The Banks – Phase 3C
Public Infrastructure Development
Bid Package #2 – Lot 28 Park & Garage
January 13, 2022
THP #98090.40

ADDENDUM #2

1 ENLARGED PLAN - LOWER LANDING BLEACHER SEATING
A510.1/ 1/4" = 1'-0"

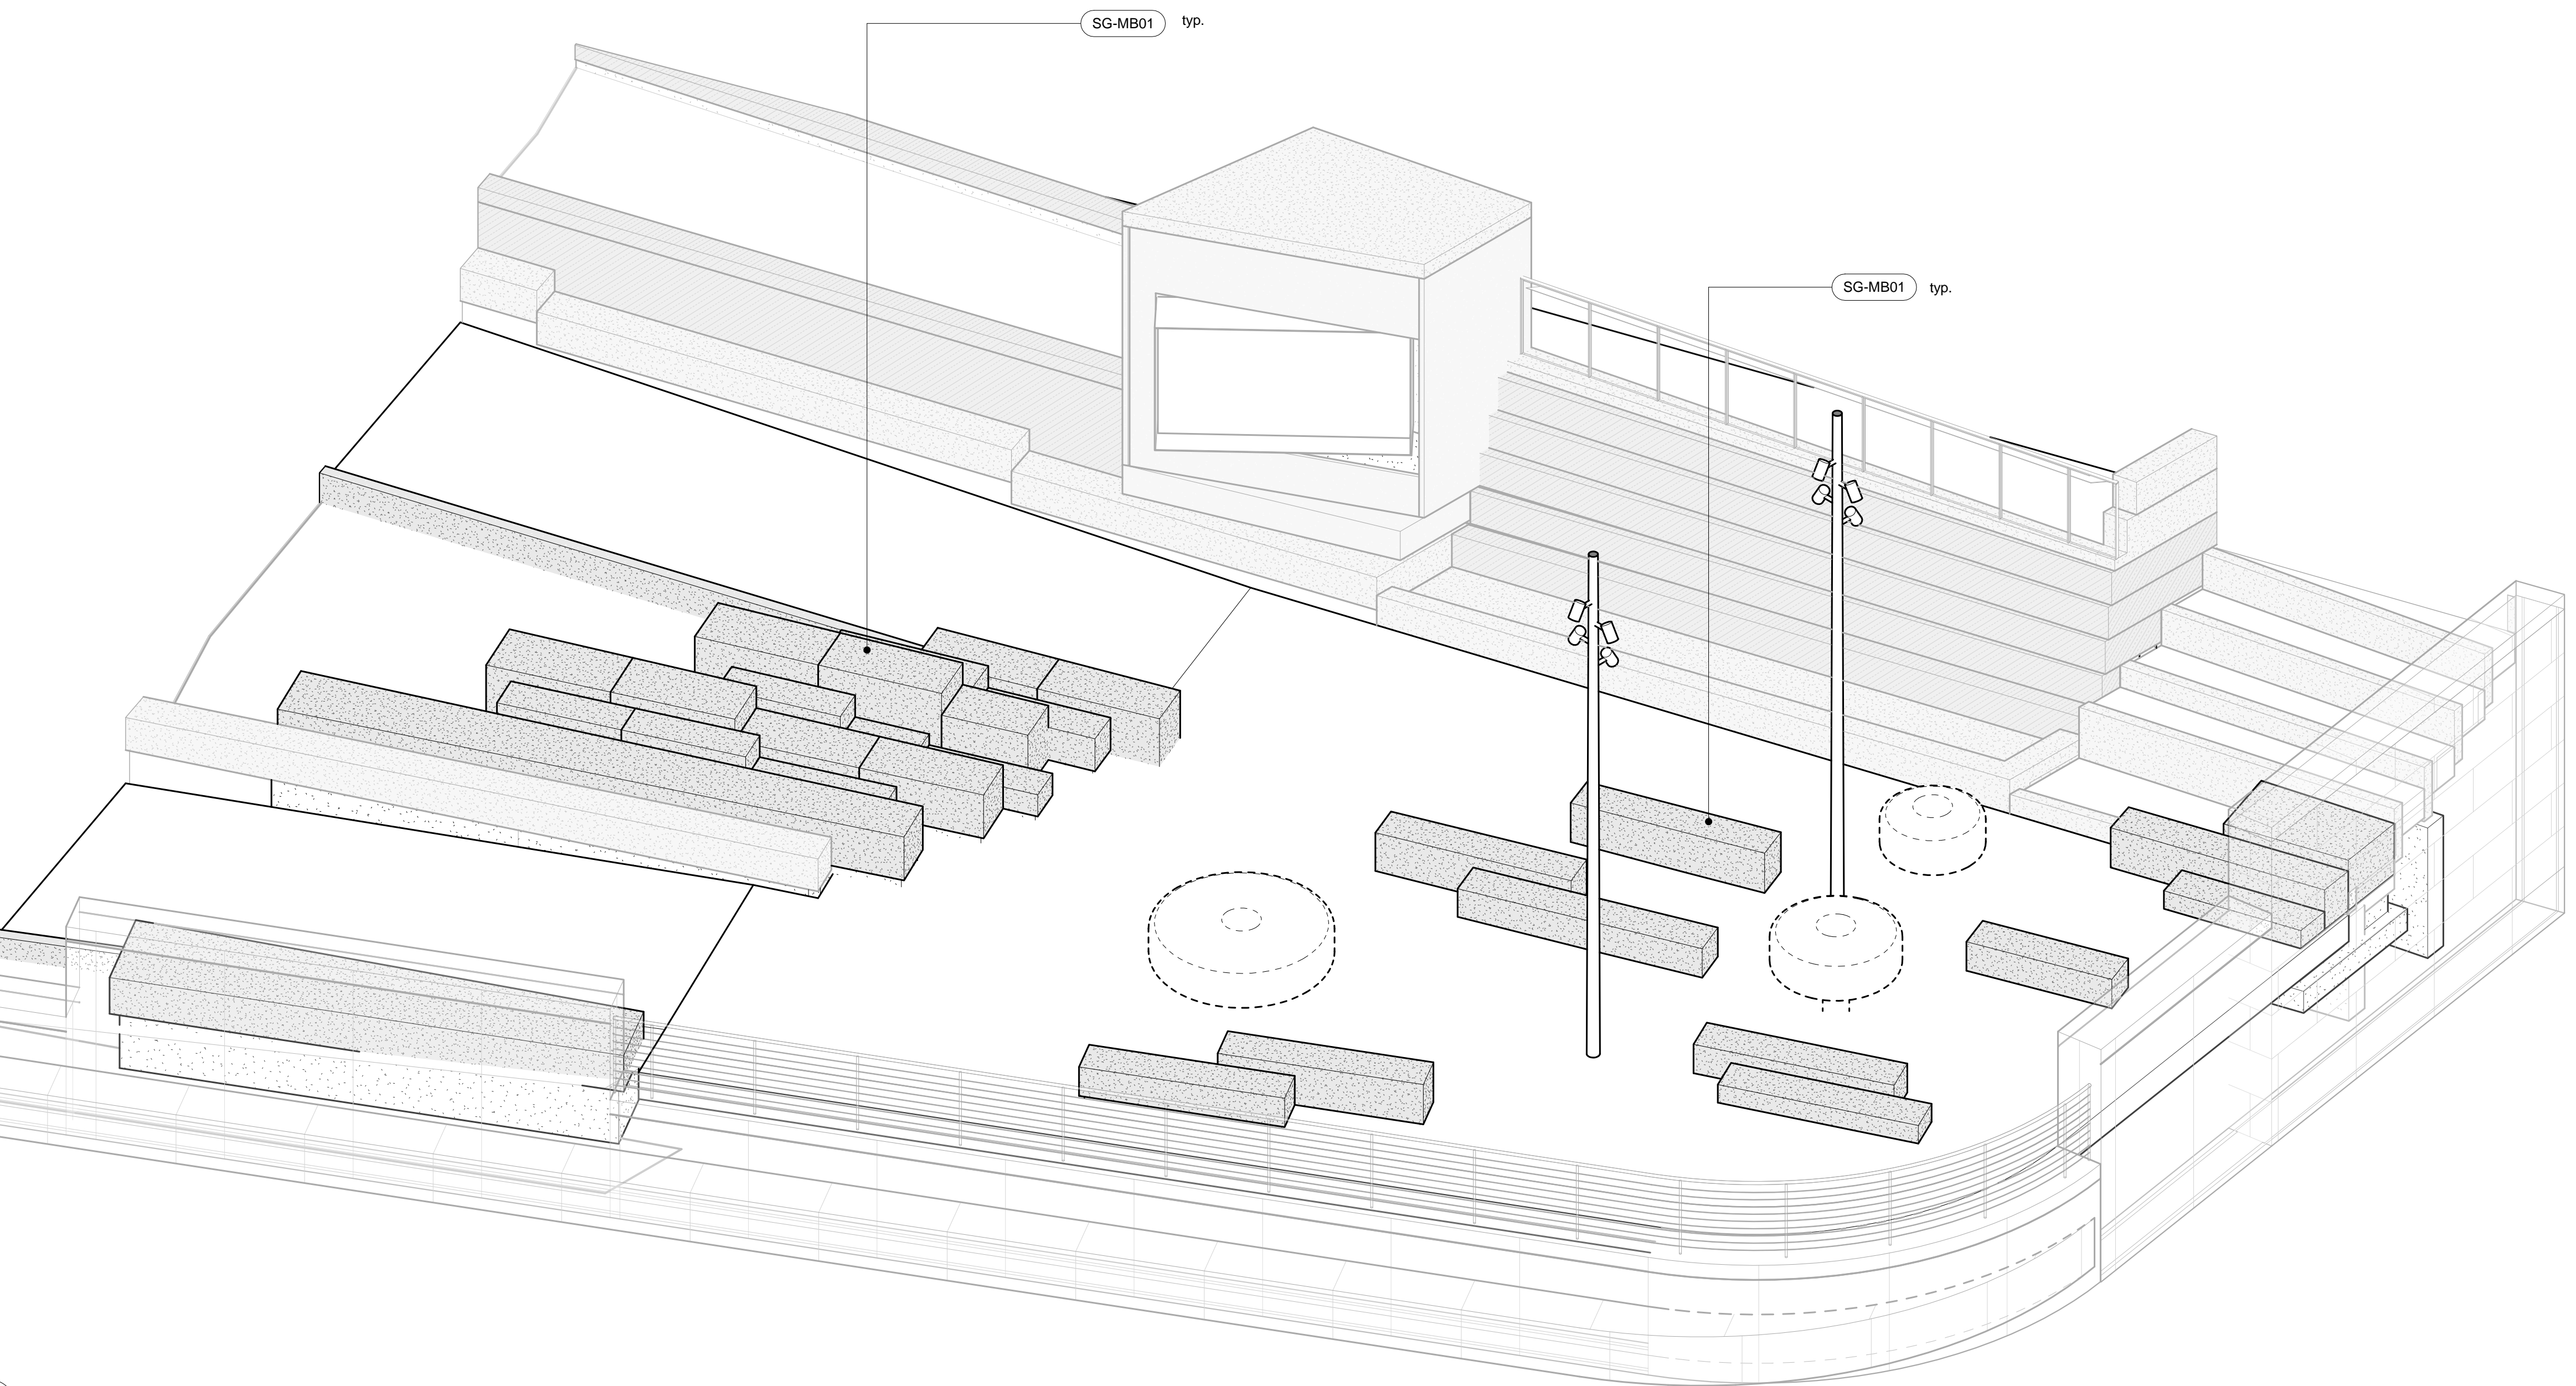
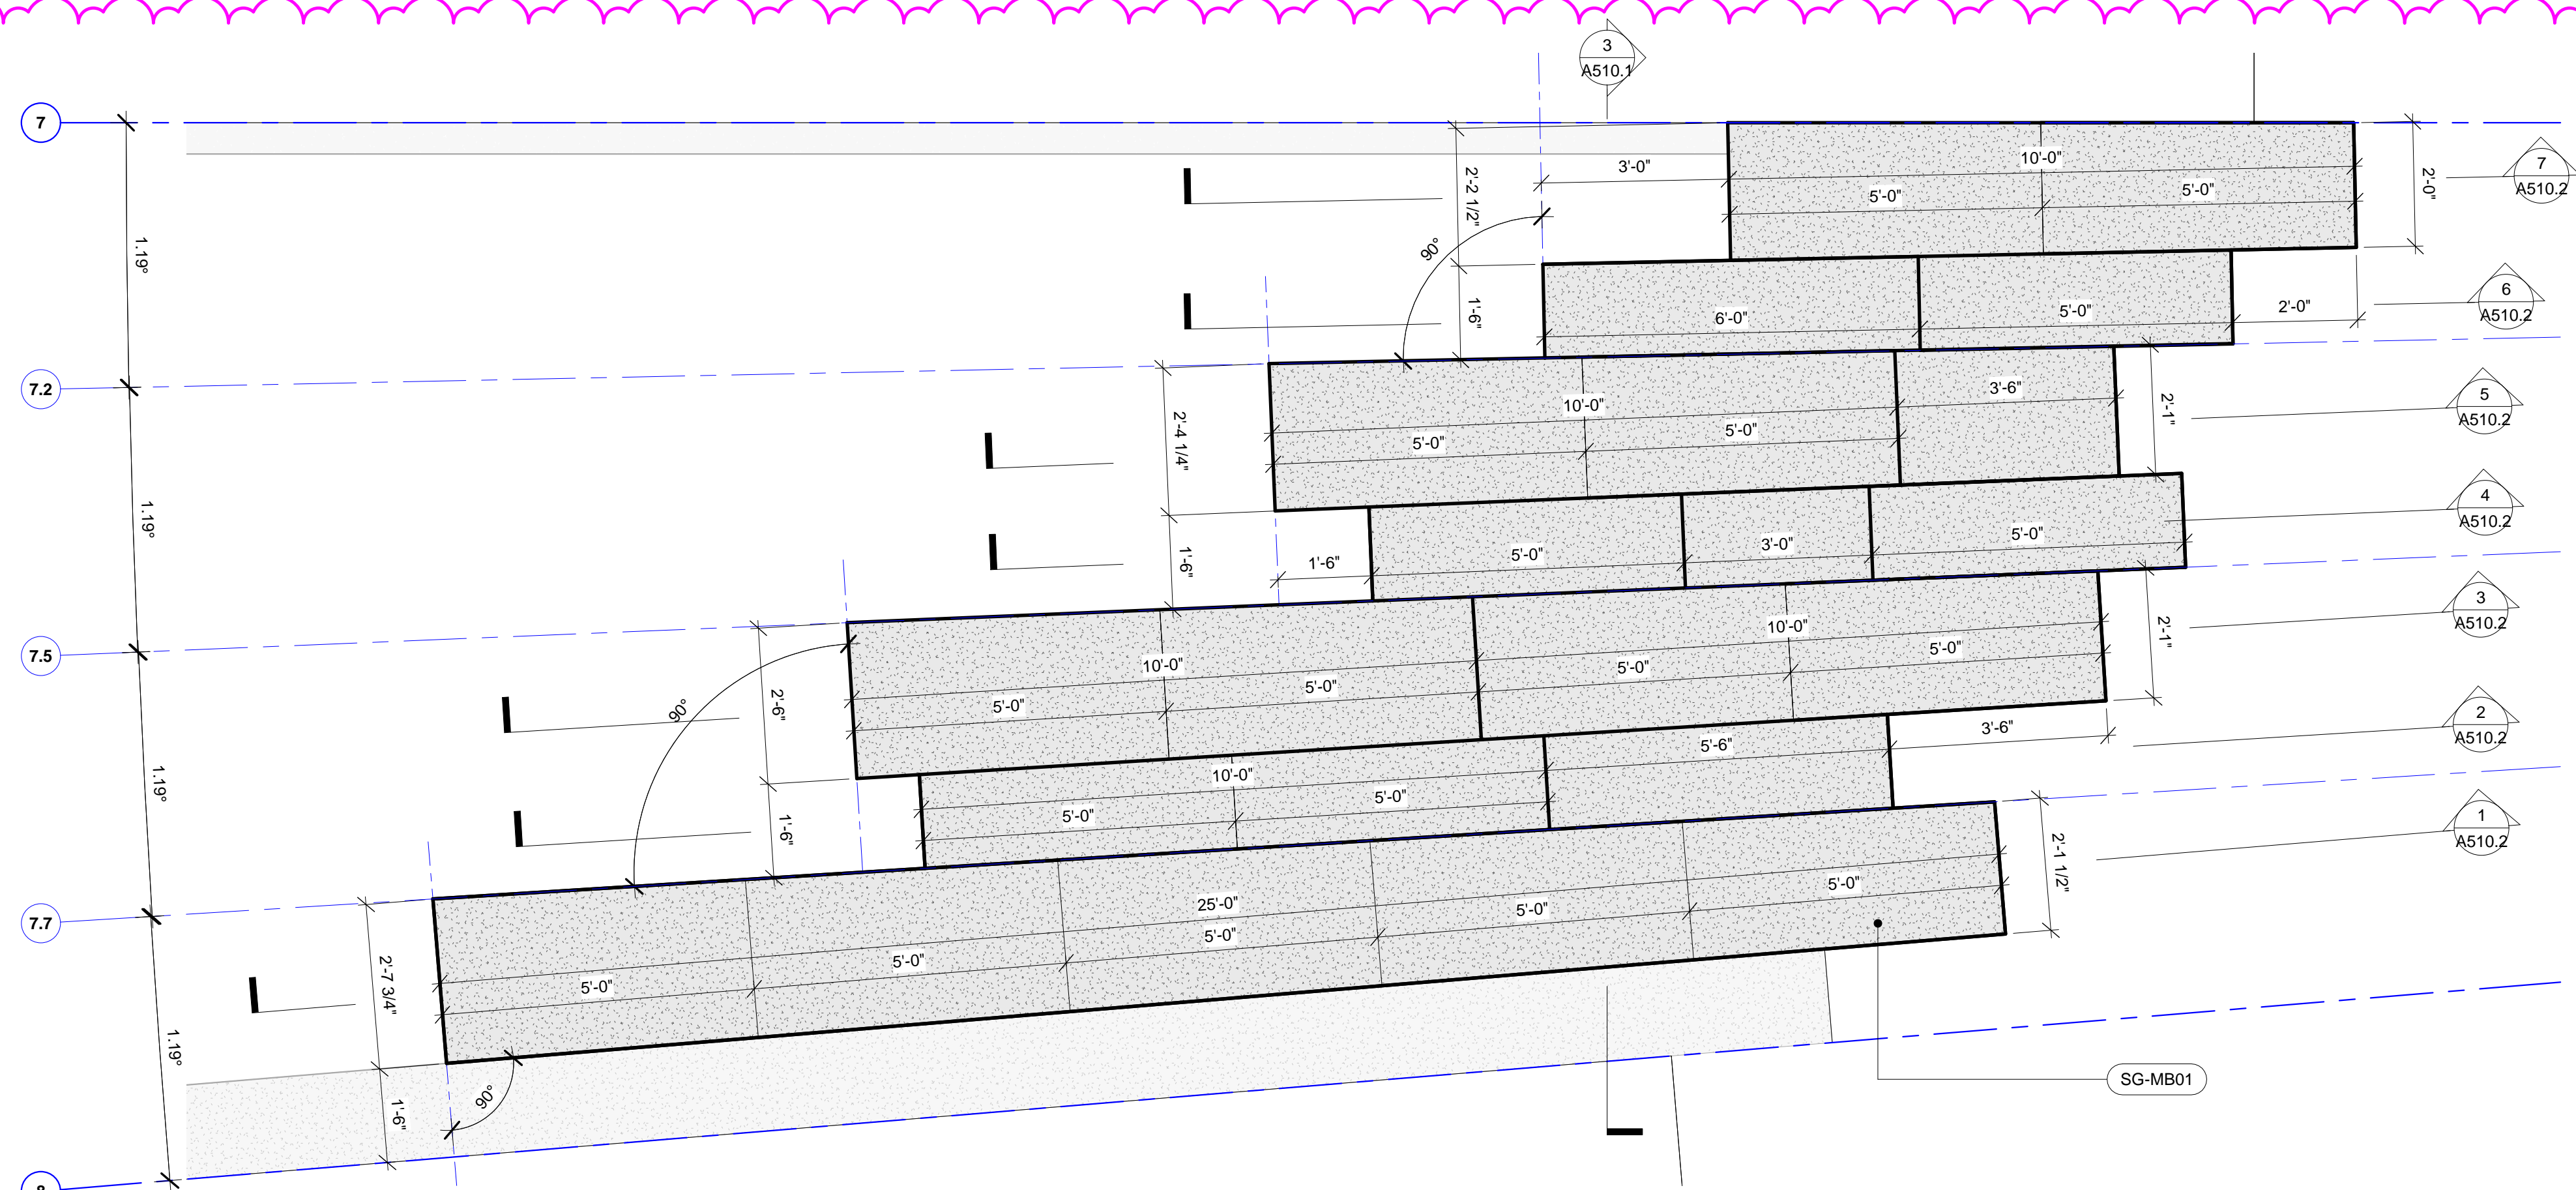
4. **A510.1** Please provide reinforcing details, elevations, and dimensions for all concrete back up foundations, for granite elements.
 - **Response to question 4:** See revised Drawing A510.1 in Addendum #2.

5. **A510.1** Detail 2/A510.1 depicts a granite structure to the east of the of the viewing screen structure. Please provide details for this area?
 - **Response to question 5:** See new Drawings A350, A351 & A352 in Addendum #2.

- Added granite bench details w/ structural notes (Baker question 4).
- Updated section w/ detail callout.
- Added new section to address east granite seat cluster (Baker question 5).
- Added notes for top of bench for scattered benches.
